Planning and Zoning Board

P&Z CASE NUMBER: Z16-009 (PLN2015-00581)
LOCATION/ADDRESS: 1000 block of North Greenfield Road (east side)
GENERAL VICINITY: Located south of the southeast corner of Greenfield Road and Brown Road.
REQUEST: Rezoning from AG to RS-15-PAD and Site Plan Review. Also consider the preliminary Plat for “Estates at Valencia South”
PURPOSE: The development of a single residence development
COUNCIL DISTRICT: District 6
OWNER(S): Arilje Properties, LLC
APPLICANT: Paul Dugas, Pinnacle Ridge Holdings, LLC
STAFF PLANNER: Lesley Davis

Applicant Proposed

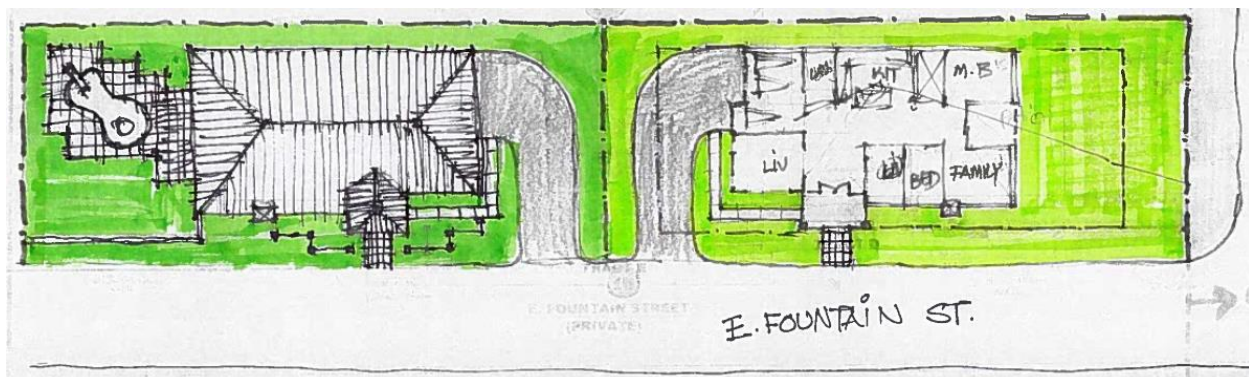
The homes that will be constructed on the lots would be a continuation of the product approved for the Estates at Valencia, however there are two lots proposed for an unusual configuration and could have a negative impact on the streetscape and neighborhood character.

The applicant has proposed that the configuration of lots 7 and 8 be interpreted to have their front setback measured from an eyebrow/curve in the road with their driveway entrance off of this widened pavement section, thus leaving the side elevation as the primary element along the street. An exhibit has been provided by the applicant that identifies how one of their house plans would fit on these two lots. Staff's concern with the design as shown on the exhibit is the street presence of those two homes to the neighborhood. The view from the street and the four homes that would face these two lots would be of a 6-foot wall behind a 10-foot landscape strip, the outside wall of a garage and the front of a side entry garage.

Staff proposes an alternative that would allow the widest portion of the lot to be considered the front of the home, with a reduced rear setback allowance of 10-feet. The currently proposed 10-foot landscape tract along Fountain Street would be incorporated into the lot depth. Staff would then propose that the home design and fence locations be more similar to the old ranch style homes where the lots were wider and shallow with a front door facing the street. This would also allow the street eyebrow to be removed and incorporated into the lots. The applicant will need to provide a house design that provides a front along Fountain and comply with the Building Form Standards established in the Zoning Ordinance for garages. Staff would recommend that one side yard for each of lots 7 and 8 maintain a minimum side yard of 20-feet to maintain a usable yard. (See conditions 9 and 10)

9. **Amend the site plan and preliminary plat to remove the eyebrow in the street and face the homes to East Fountain Street. The plat shall be revised prior to submission for Subdivision Technical Review.**

10. **Introduce housing product or a custom home design for lots 7 and 8 that provide a front door and appropriate detailing for the front of a home along East Fountain Street. Details shall be approved by the Planning Director prior to submitting for building permits for homes on lots 7 and 8.**
